# Service Bulletin

Bulletin No.: 19-NA-015

**Subject: HVAC Temperature or Mode Control Inoperative**

2772058

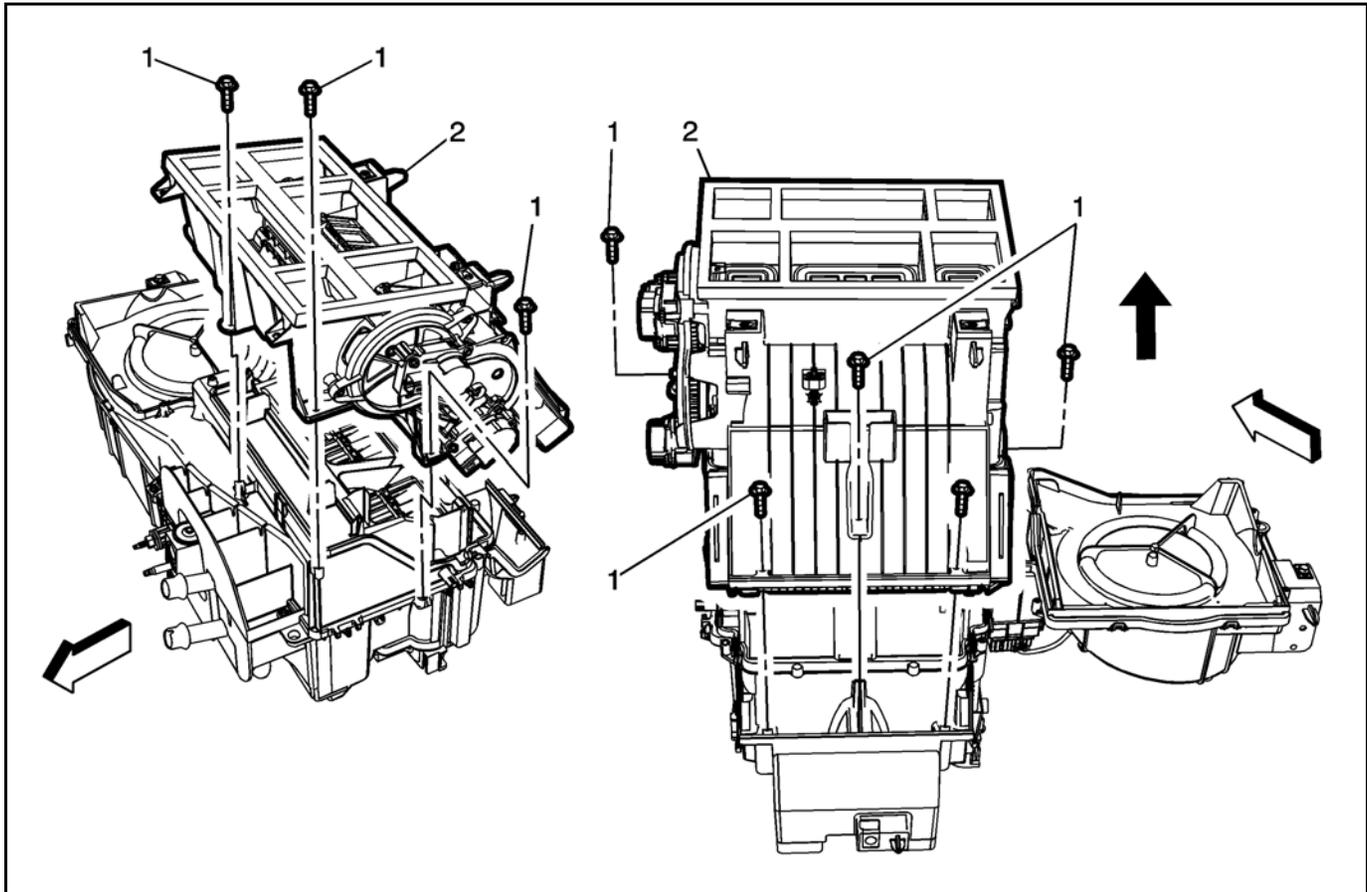
<b>Involved Region or Country</b>	North America, Brazil, Europe, Israel, Middle East, China, GM Korea Company, Malaysia, Uzbekistan
<b>Condition</b>	Some customers may comment on one or more of the following concerns: <ul style="list-style-type: none"> <li>• Temperature control inoperative</li> <li>• No heat</li> <li>• No defrost</li> </ul>
<b>Cause</b>	This condition may be caused by the air conditioning evaporator case not aligning with the upper HVAC housing case, causing the control gears not to engage properly when adjusting the temperature.
<b>Correction</b>	<ol style="list-style-type: none"> <li>1. Check the temperature and mode cables operation as instructed in Service Bulletin 17-NA-113 (Document ID# 4694428).</li> </ol> <p>⇒ If the gear mesh is lost during adjustment, replace the air conditioning evaporator case.</p> <ol style="list-style-type: none"> <li>2. With the cable detached, verify that the mode and/or temp doors move freely.</li> </ol> <p>⇒ If the doors are sticking with the cables detached, replace the air conditioning evaporator case.</p> <p><b>Note:</b> When replacing the case, a new cable retention feature has been added to prevent kinking of the cable.</p>

Refer to *Air Conditioning (A/C) Evaporator Case Assembly Replacement* in SI.
